From: "BENNETT, STEVE A" <SBENNE2@entergy.com>
To: "Tom Alexion" <twalex@nrc.gov>
Date: 11/5/02 9:14PM
Subject: ANO-1 Draft Response to NRC Bulletin 2002-01

**Request for Additional Information Related to Bulletin 2002-01
Arkansas Nuclear One, Unit 1 (ANO-1)**

Reactor Vessel Skirt Openings and Locations Plan View – Looking UP

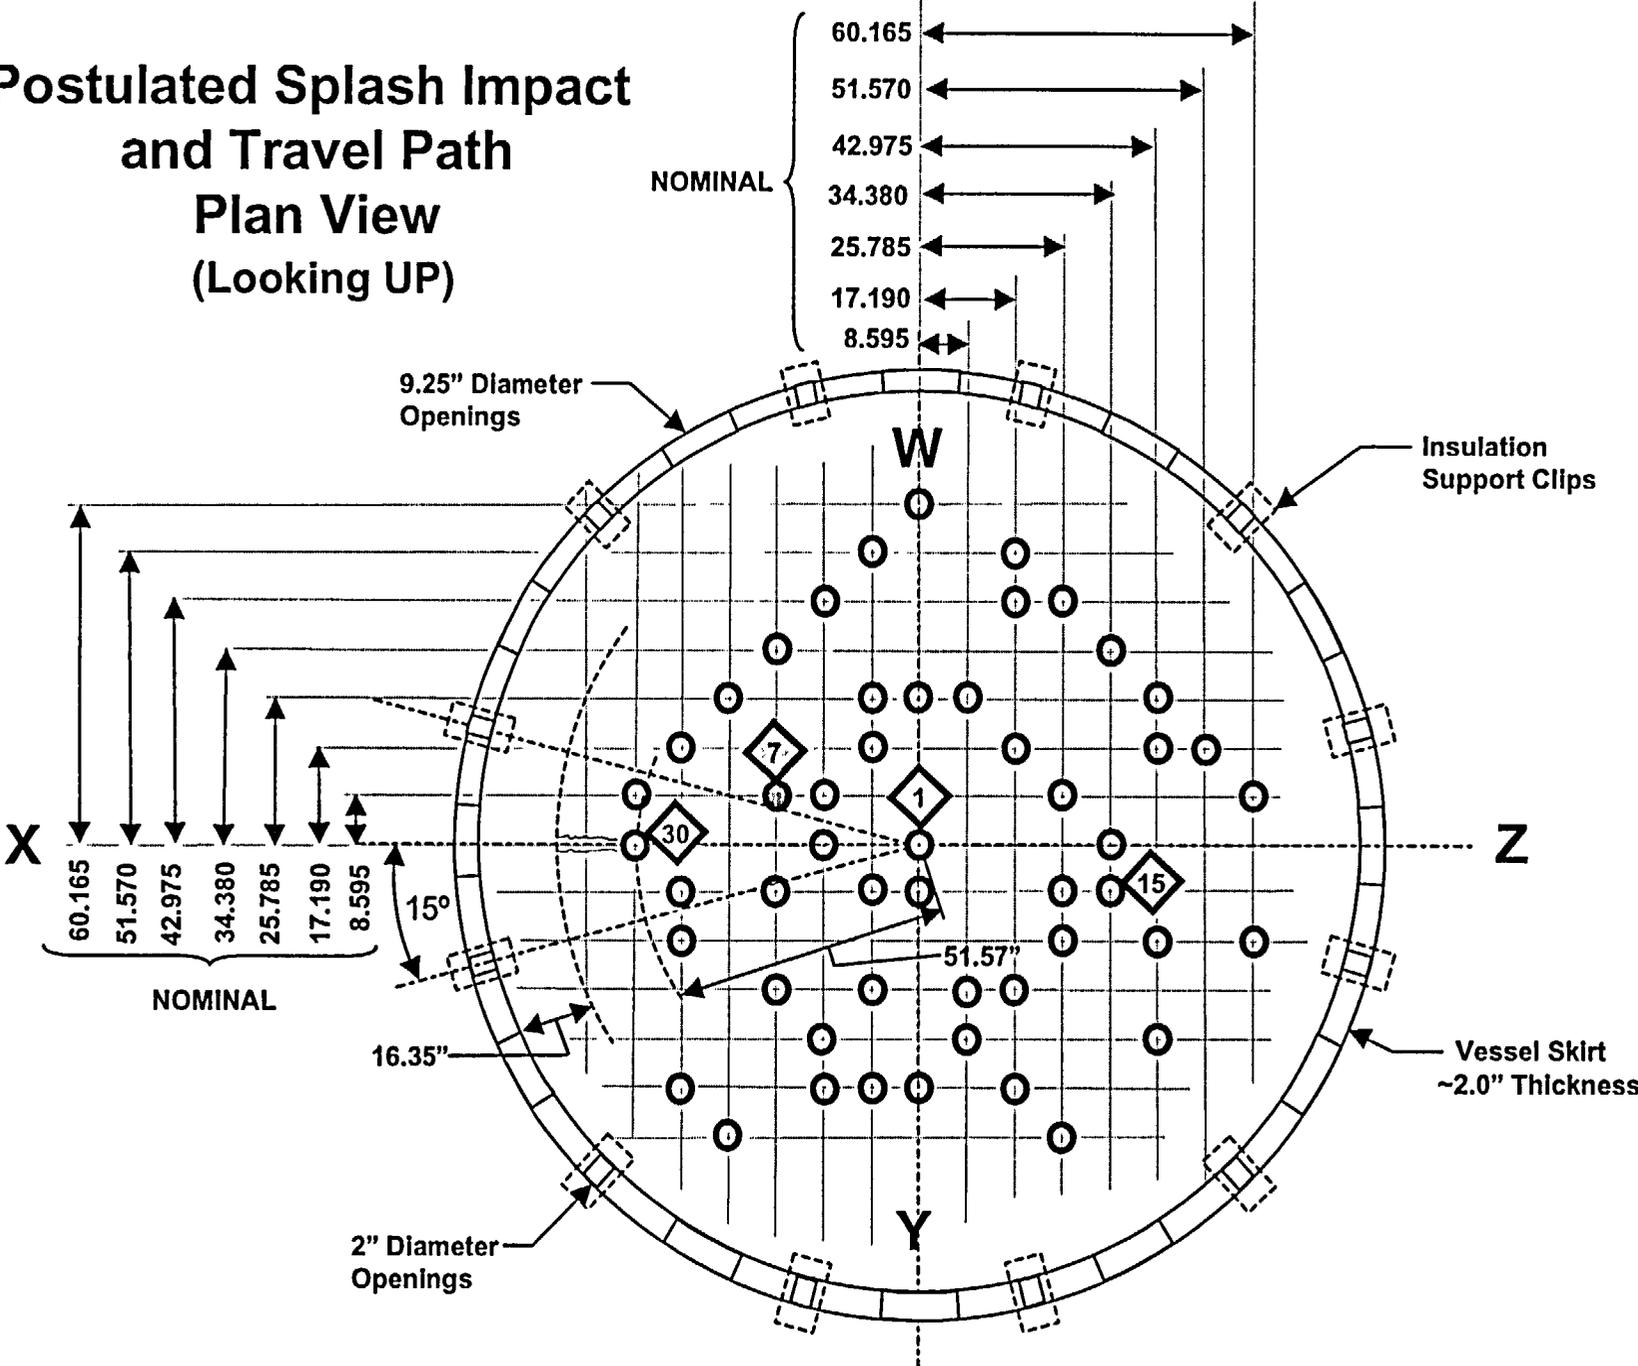
1. Provide detailed drawings and dimensions of the vessel bottom (including the vessel skirt, insulation, etc.) showing the instrumentation nozzles; include on these drawings the boric acid deposits (e.g. staining) based on information obtained from your video tapes. Show the nozzles in the vicinity of nozzle 30 down to nozzle 1 and in the vicinity of nozzle 15 down to nozzle 1.

2. Explain your best efforts to locate the source of the boric acid deposits. Address the feasibility of performing additional inspections of the annulus between the vessel/support skirt and the vertical insulation or from the under vessel area to provide further evidence of the path of borated water through the 2 inch support skirt openings.

Attachment 1 (Diagrams of penetrations through vessel skirt, nozzle layout, and description) identifies the nozzles that were inspected using a boroscope and the results. The four nozzles inspected by a boroscope were the only incore tubes that had staining below the insulation. The purpose of the boroscope inspection was to determine whether these nozzles had any evidence of leakage at the vessel interface. Attachment 2 provides a scale composite drawing showing the dimensions of the reactor vessel, support skirt, insulation details, and nozzle 1 and 30.

The reactor cavity seal plate leakage would traverse the annulus area between the vessel and the mirror insulation to reach the undervessel area. The ability to perform additional inspections of the vertical annulus area between the vessel and the mirror insulation has been evaluated. To provide direct visual evidence of the path of borated water through the 2 inch holes in the support skirt above the undervessel insulation, access to the annulus would have to be gained. Possible access routes to inspect the area are limited to access from the top of the reactor vessel and access from below the vessel. There are no access locations between the top and bottom of the vessel because of the primary shield wall. The only openings through the shield wall are around the reactor vessel nozzles and these are too tight a fit to permit access. Access from the top of the vessel to the annulus between the shield wall and the reactor vessel is restricted by the reactor shield blocks. They consist of concrete filled, steel lined blocks. The shield blocks are located below the permanent seal ring at the top of the vessel and above the reactor vessel nozzles. These shield blocks provide a radiation shield in the annulus between the top of the reactor vessel and the floor of the refueling canal. There is no access through these blocks without removing them from above. This can only be accomplished by removing portions of the permanent seal plate.

The only other access to the area between the vessel skirt and the vessel insulation is from the bottom of the vessel. Access of this area is difficult to accomplish. One horizontal insulation panel in proximity to nozzle 30 could be removed to gain access to the area below the holes and a boroscope inserted through the area between the two adjacent incore nozzles, up to the accessible two (2) inch diameter holes located
